**TOWN OF GLASTONBURY
GL-2018-05**

**ADDISON ROAD SIDEWALK PROJECT
MAIN STREET (RT17) SIDEWALK PROJECT**

ADDENDUM NO. 1

AUGUST 31, 2017

SHEET NO. **1** OF 7

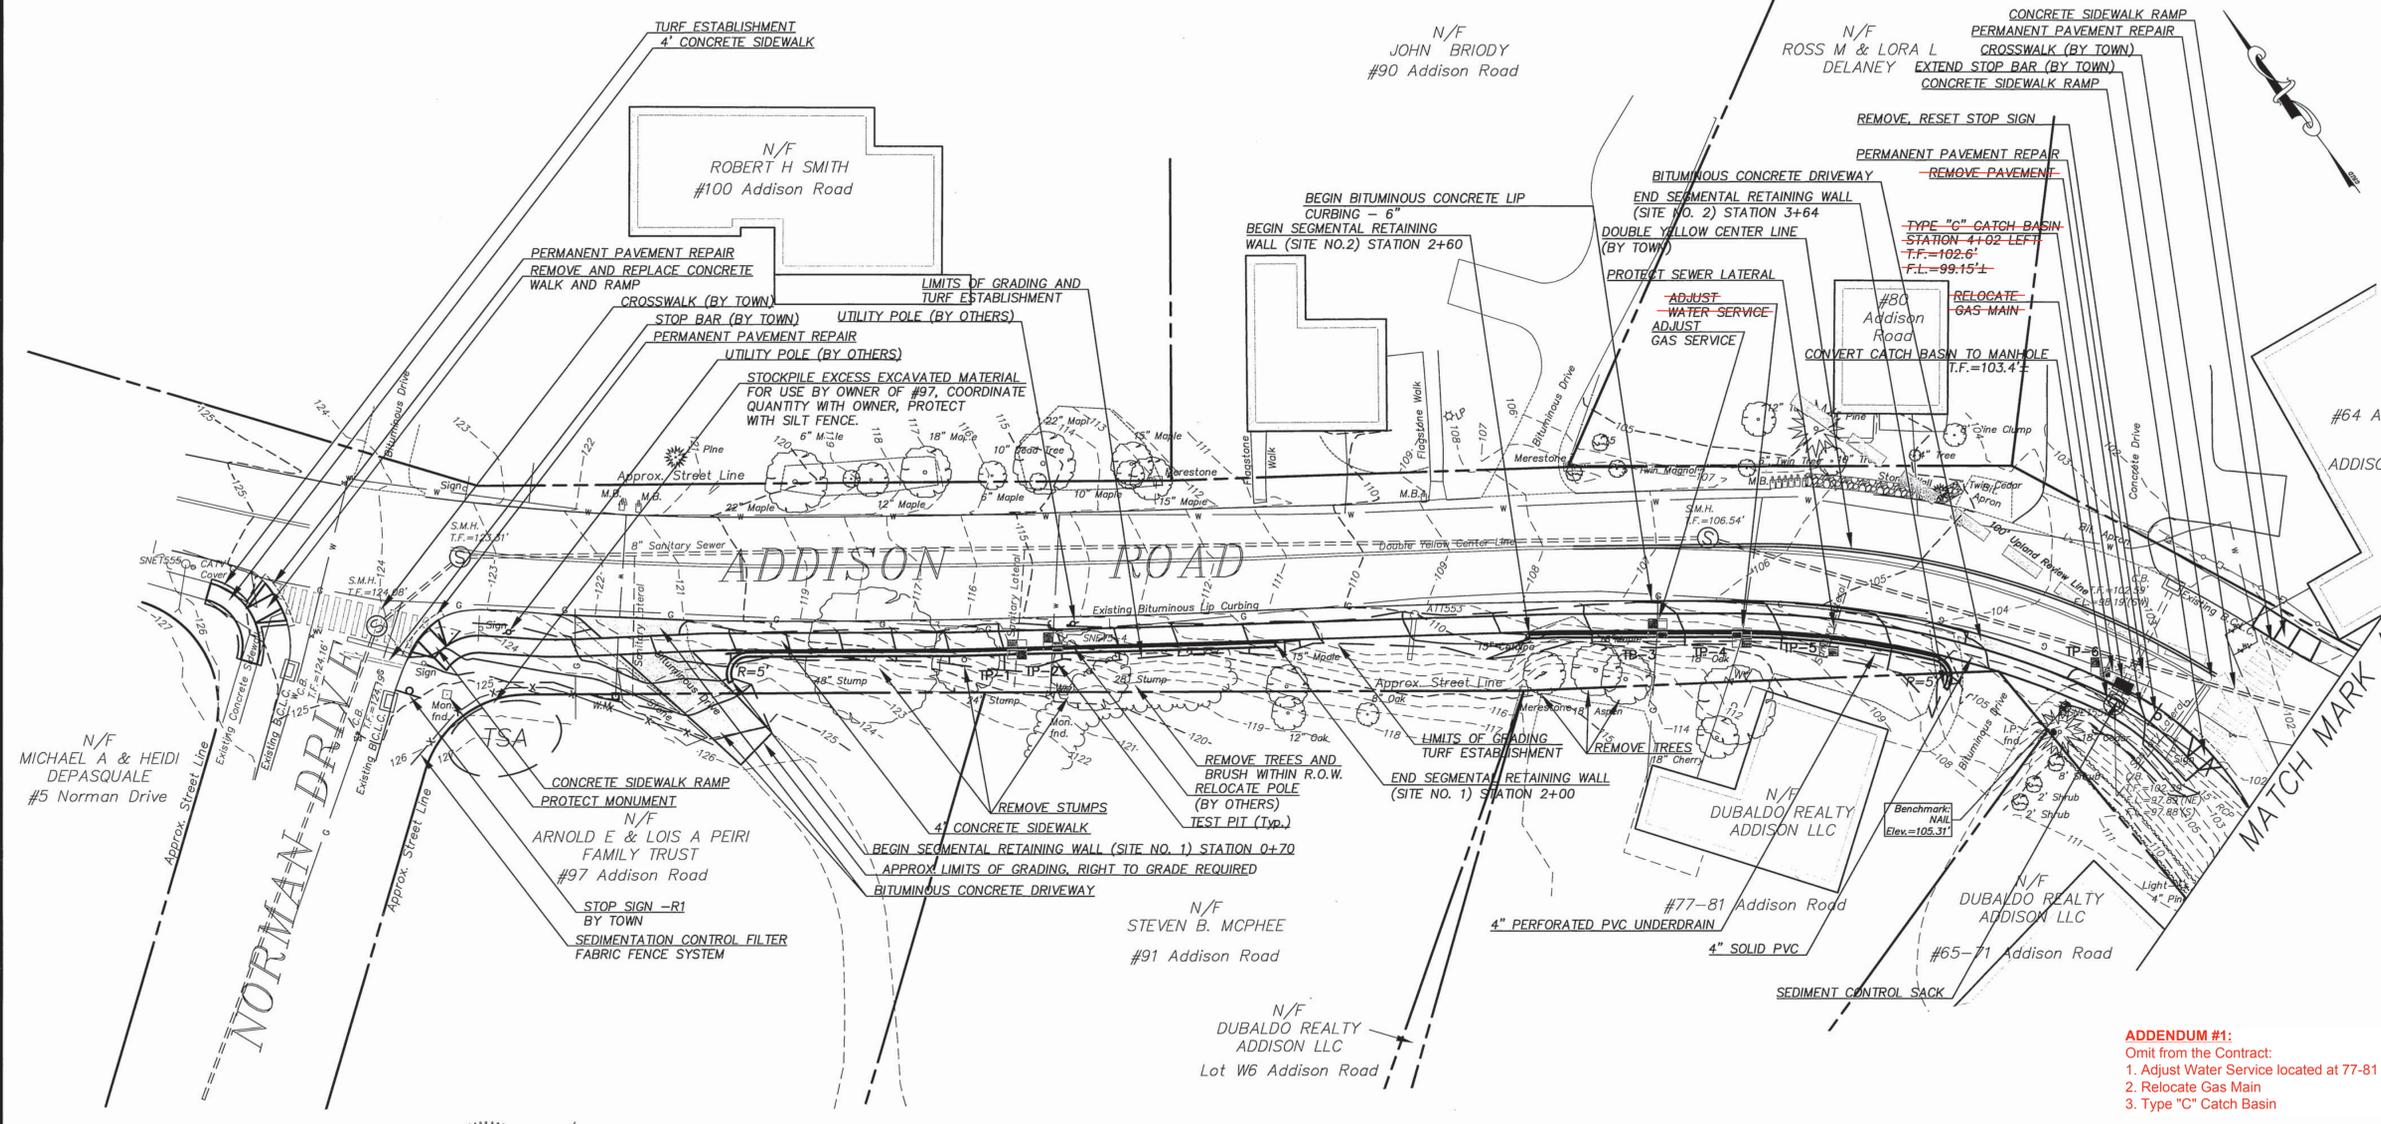
Sheets 1, 2, and 6 of the "PLANS DEPICTING PROPOSED SIDEWALKS ON ADDISON ROAD, GLASTONBURY CONNECTICUT" are hereby amended per the attached marked up plans. Changes shown on Sheets 1 and 6 include elimination of the Type 'C' Catch Basin located at Station 4+02 left from the contract and elimination of work associated with the Items "RELOCATE GAS MAIN" and "RELOCATE WATER SERVICE" since this work is no longer required. Changes shown on Sheet 2 include removal of the existing catch basin at the intersection with Mill Street and replacing it with a Type "C" Catch Basin Double Grate Type II. ConnDOT Standard Detail Sheets HW-507_06 and HW-507_07 are also added to the contract for the proposed double grate catch basin.

- ADDENDUM #1:**
- Omit from the Contract:
 - Adjust Water Service located at 77-81 Addison Road
 - Relocate Gas Main
 - Type "C" Catch Basin

SHEET NO.
2
 OF 7

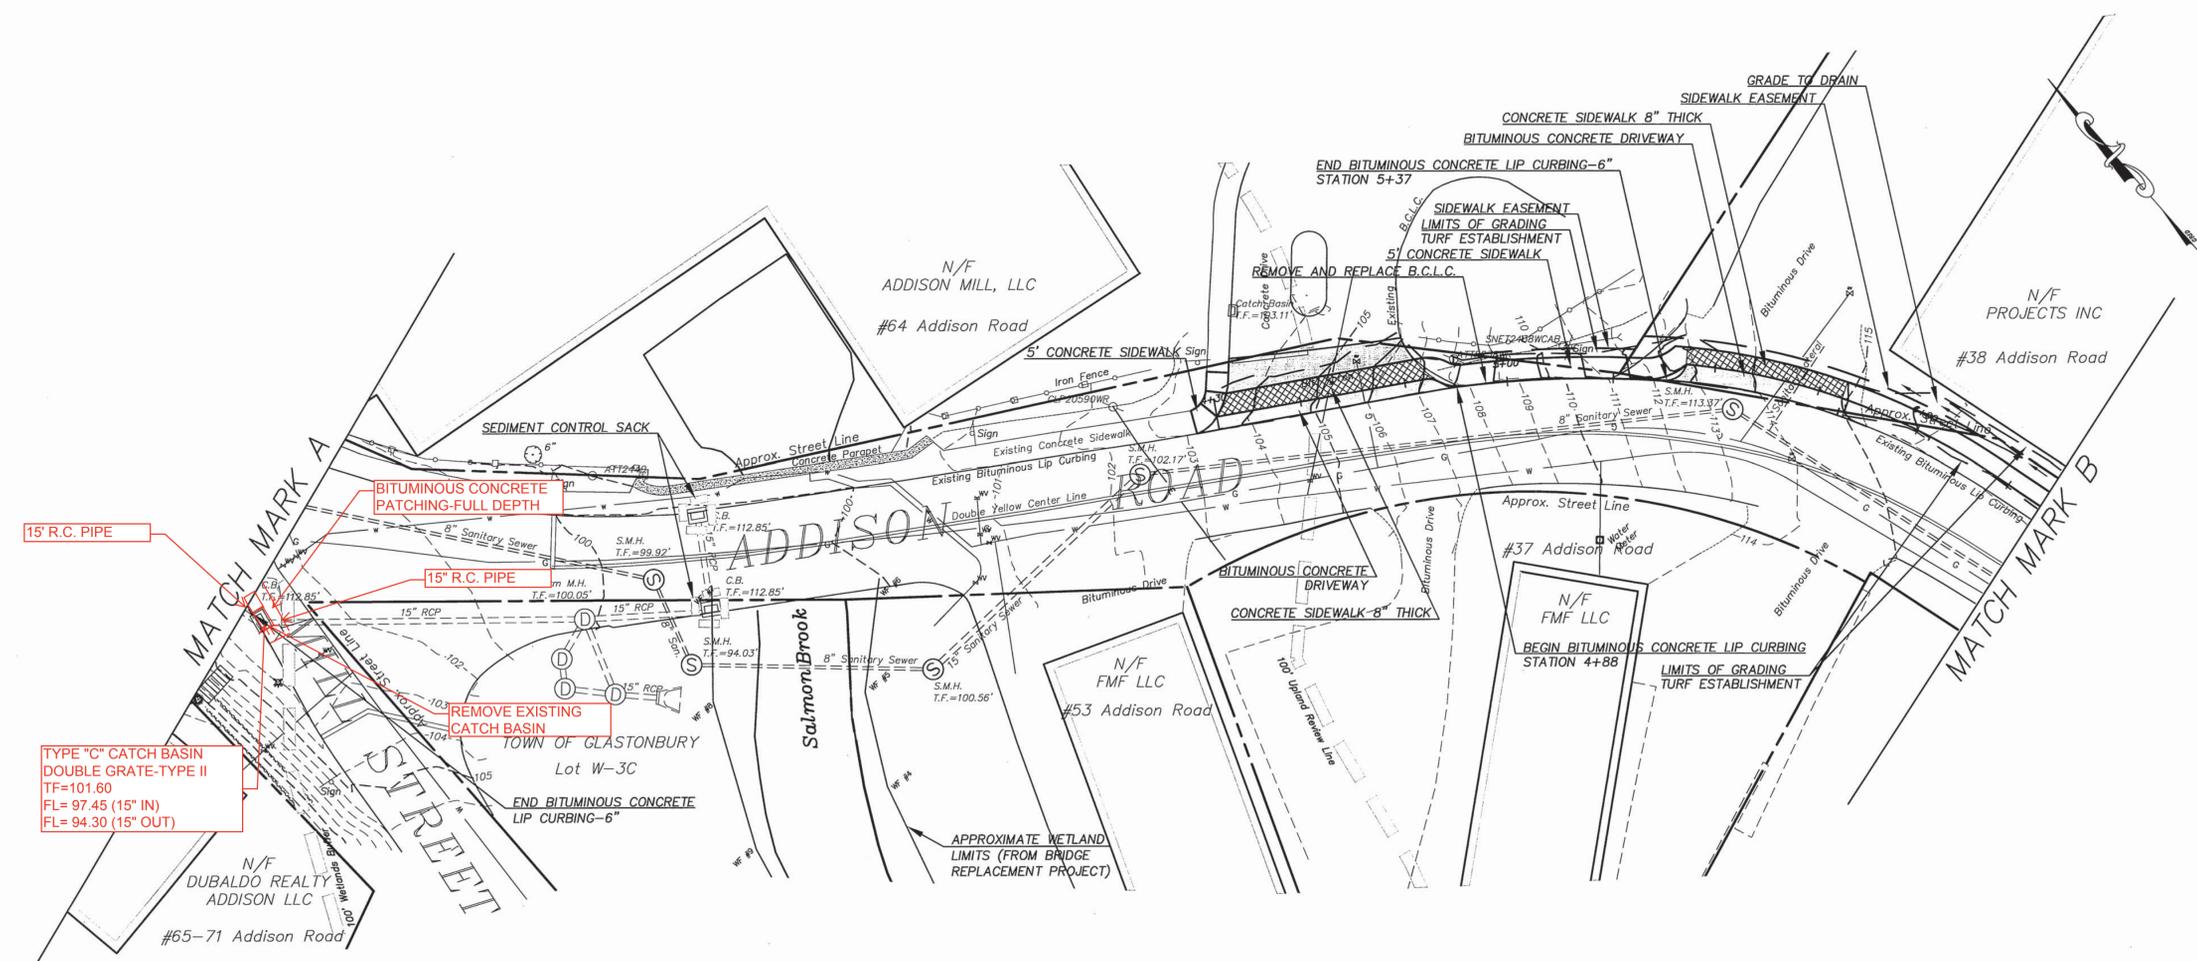
15" R.C. PIPE
 BITUMINOUS CONCRETE PATCHING-FULL DEPTH
 15" R.C. PIPE
 REMOVE EXISTING CATCH BASIN
 TYPE "C" CATCH BASIN DOUBLE GRATE-TYPE II
 TF=101.60
 FL= 97.45 (15" IN)
 FL= 94.30 (15" OUT)

ADDENDUM #1:
 Add to Contract:
 1. Type "C" Catch Basin Double Grate-Type II
 2. Bituminous Concrete Patching-Full Depth
 3. Remove Existing Catch Basin
 4. 15" R.C. Pipe
